To: T10 Technical Committee  
From: Rob Elliott, Compaq Computer Corporation (Robert.Elliott@compaq.com)  
Date: 23 September 2001  
Subject: SPI-4 negotiation message rewrite

The PPR, WDTR, and SDTR message descriptions are full of duplications and contain some errors. This proposal rewrites the three sections, moving most of the text into a model section in clause 4 and simplifying the individual sections in clause 16. It attempts to eliminate duplications and fix errors. It only attempts to change behavior that needs to be changed.

Figure 8. Target originated WDTR negotiation: target response

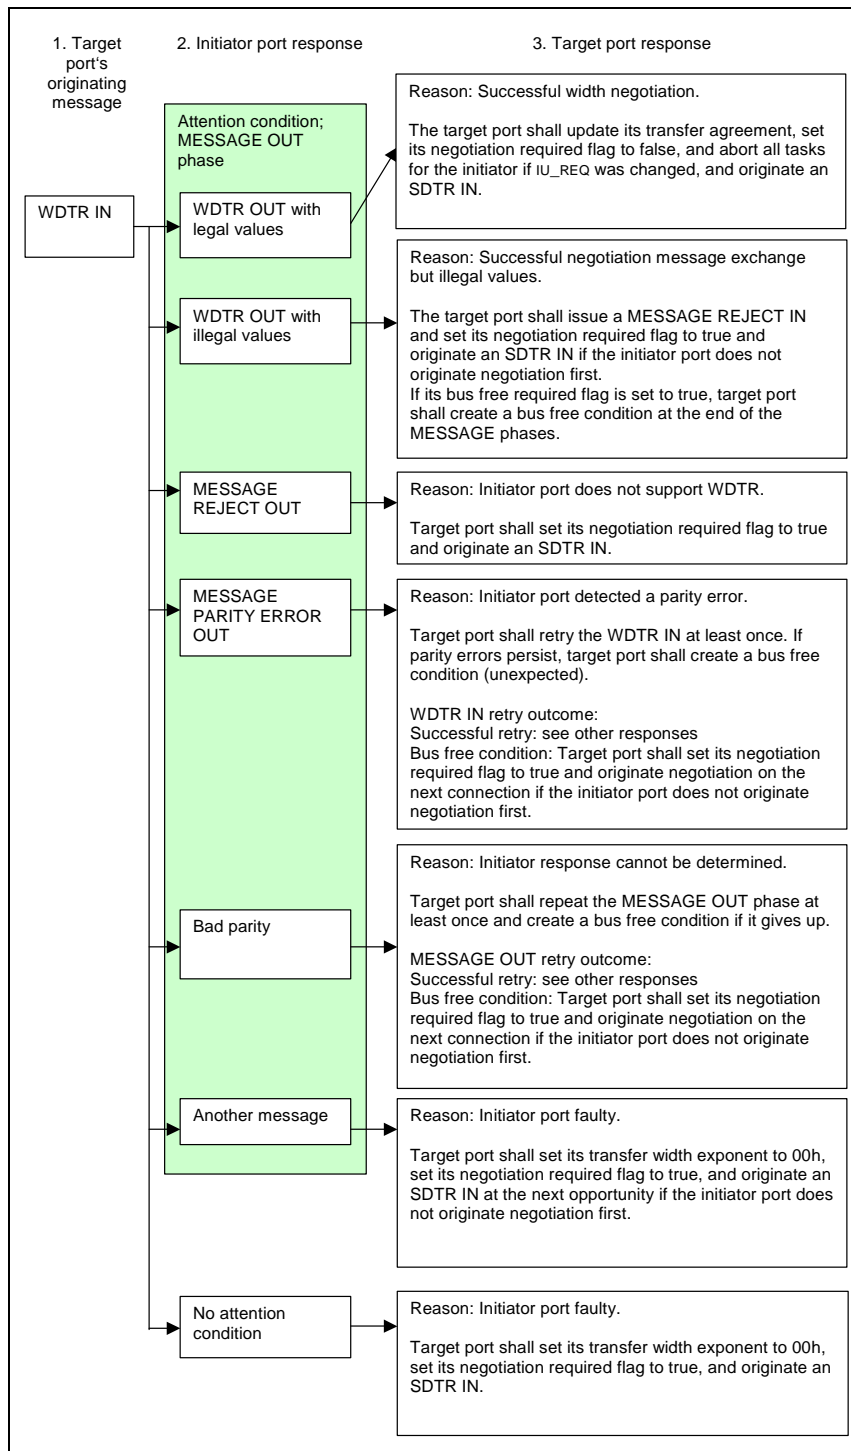
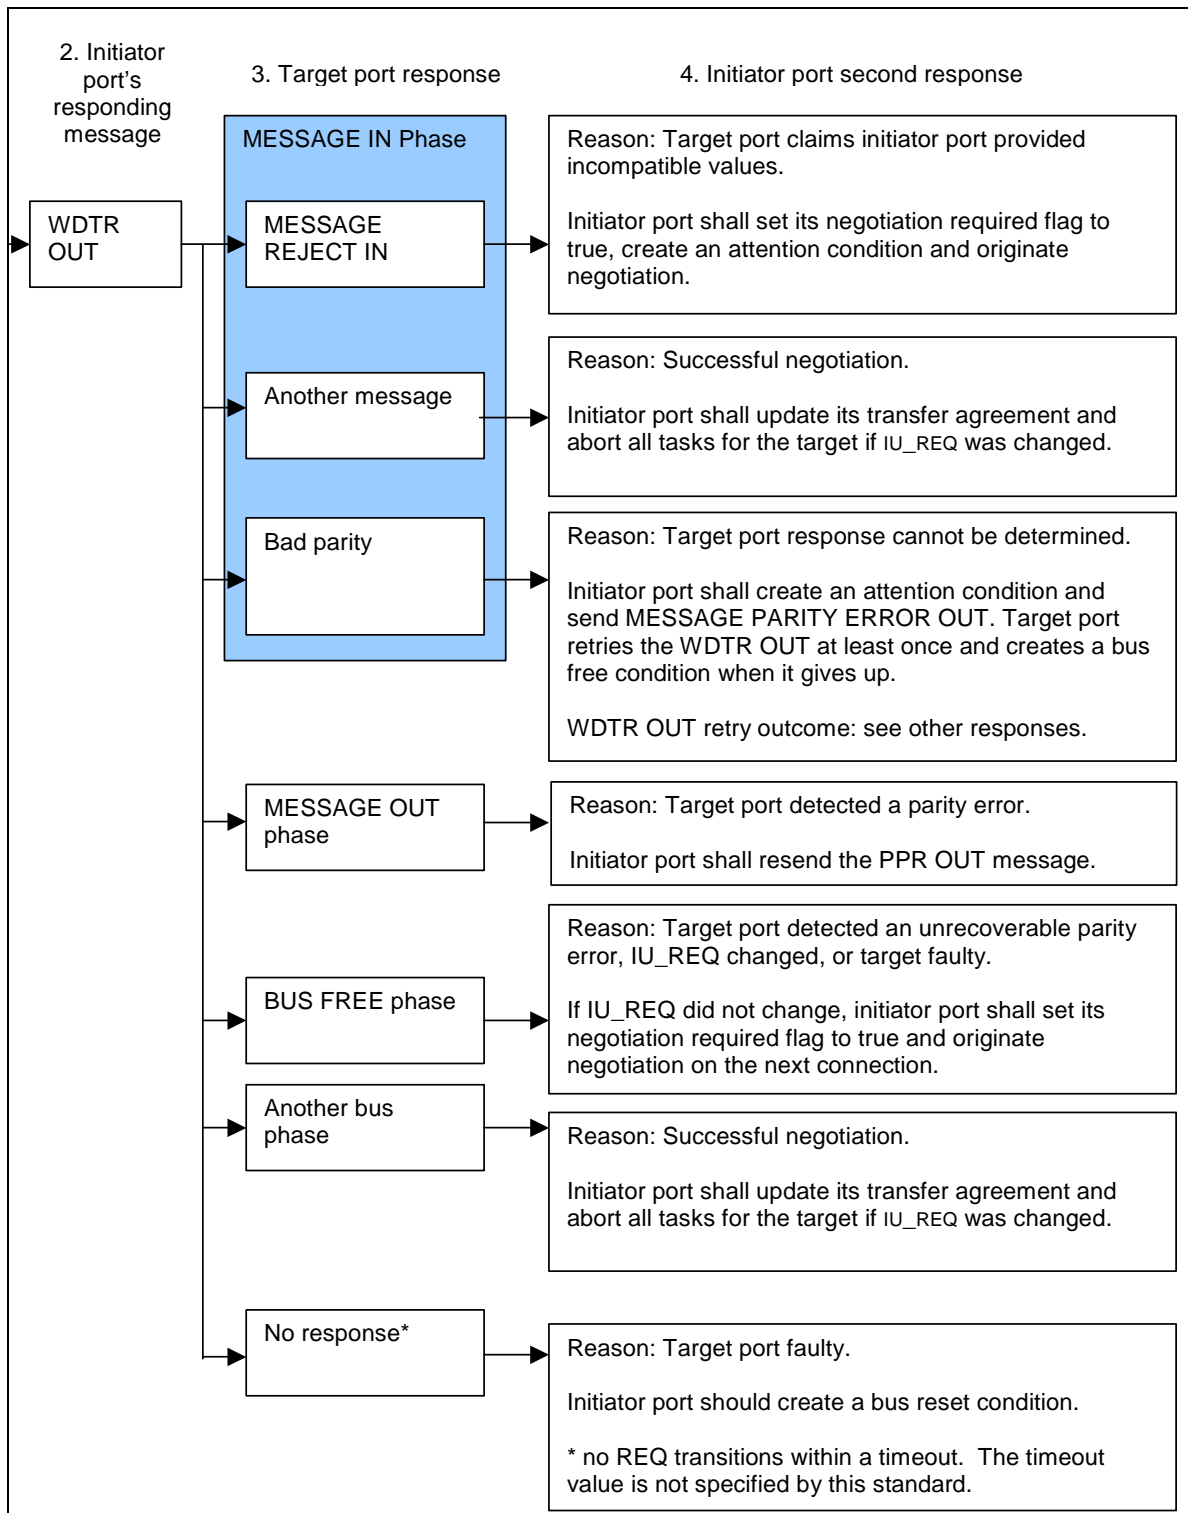
Figure 8 shows how the target port shall respond to various initiator port responses to an originating WDTR IN. The target port shall maintain the previous transfer agreement unless otherwise indicated.

Figure 9 shows how the initiator port shall respond to various target port responses to a responding WDTR OUT. The initiator port shall maintain the previous transfer agreement unless otherwise indicated.

Figure 10. Target originated SDTR negotiation: target response

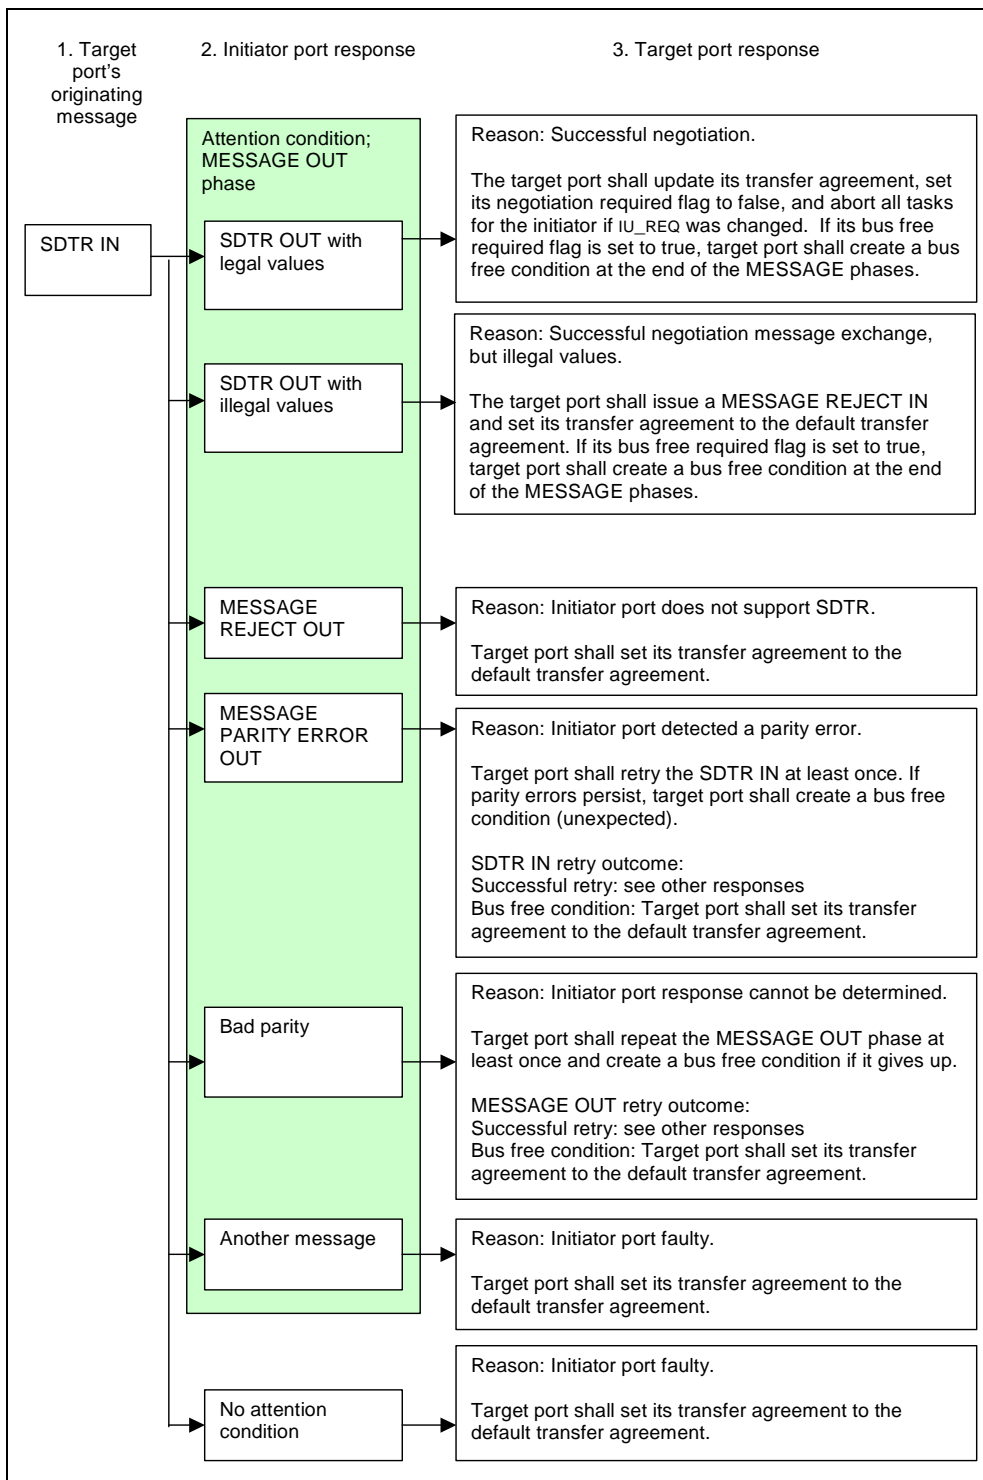
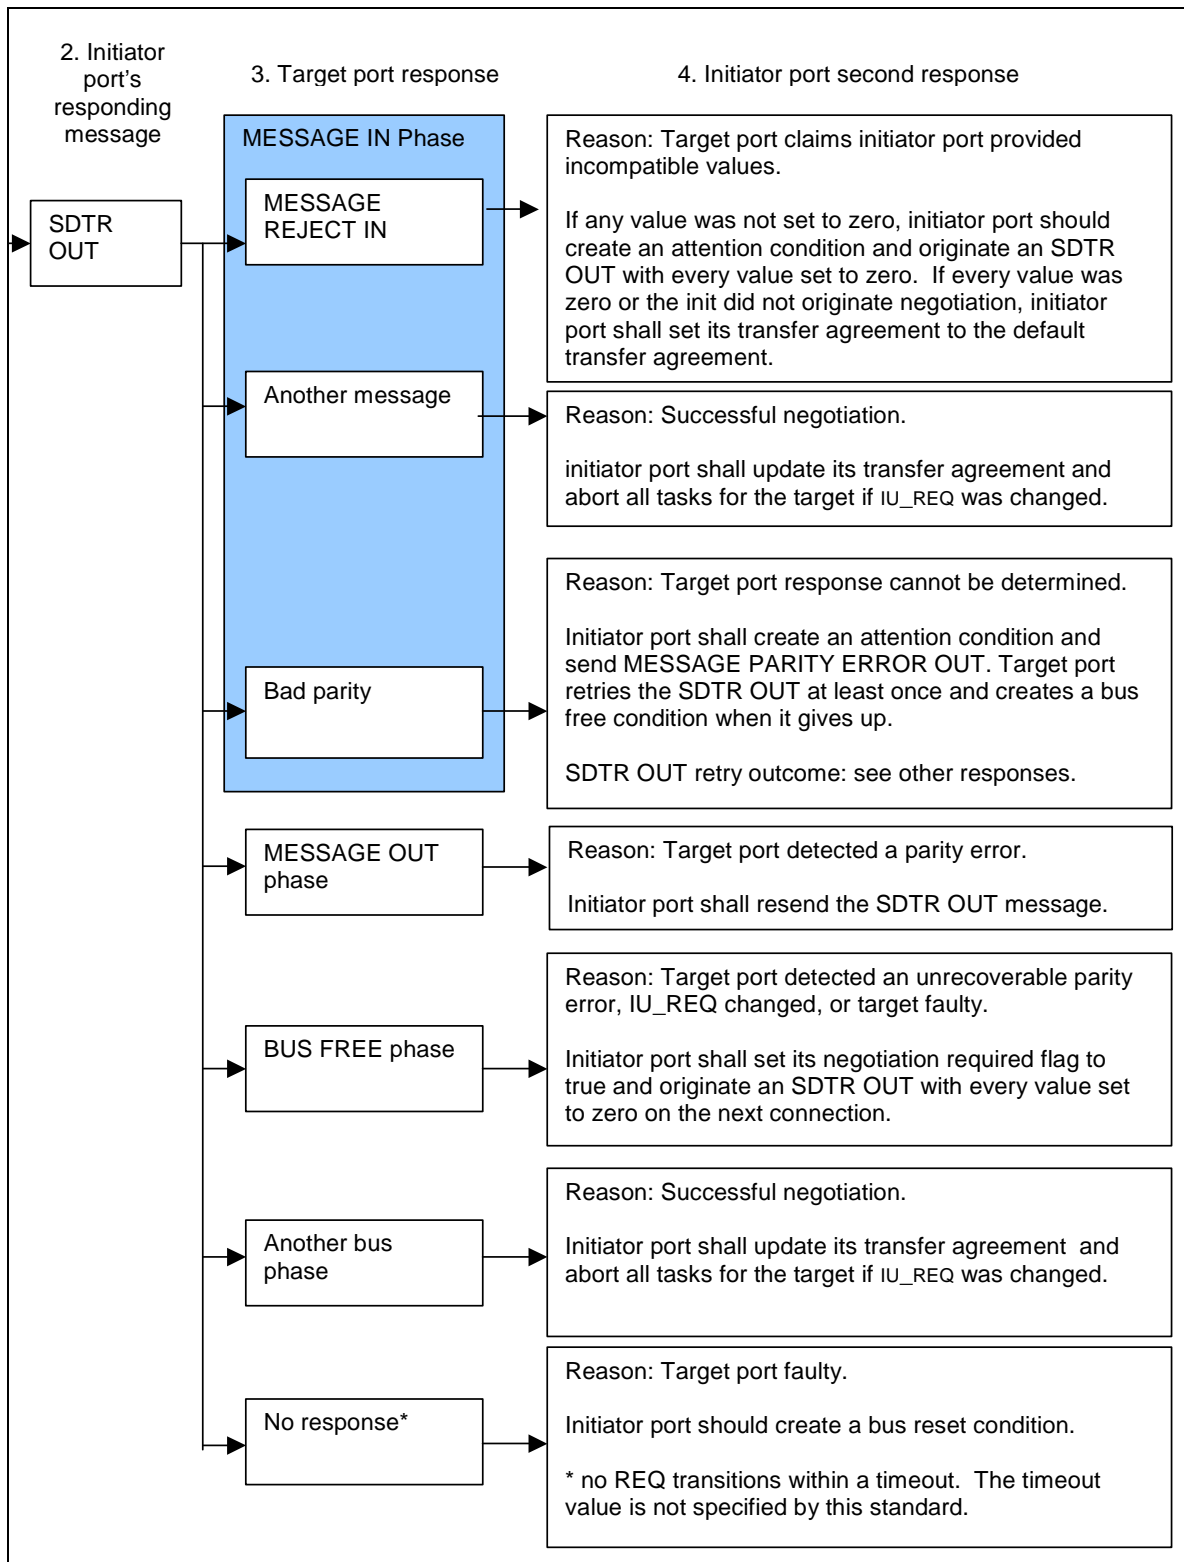
Figure 10 shows how the target port shall respond to various initiator port responses to an originating SDTR IN. The target port shall maintain the previous transfer agreement unless otherwise indicated.

Figure 11 shows how the initiator port shall respond to various target port responses to a responding SDTR OUT. The initiator port shall maintain the previous transfer agreement unless otherwise indicated.
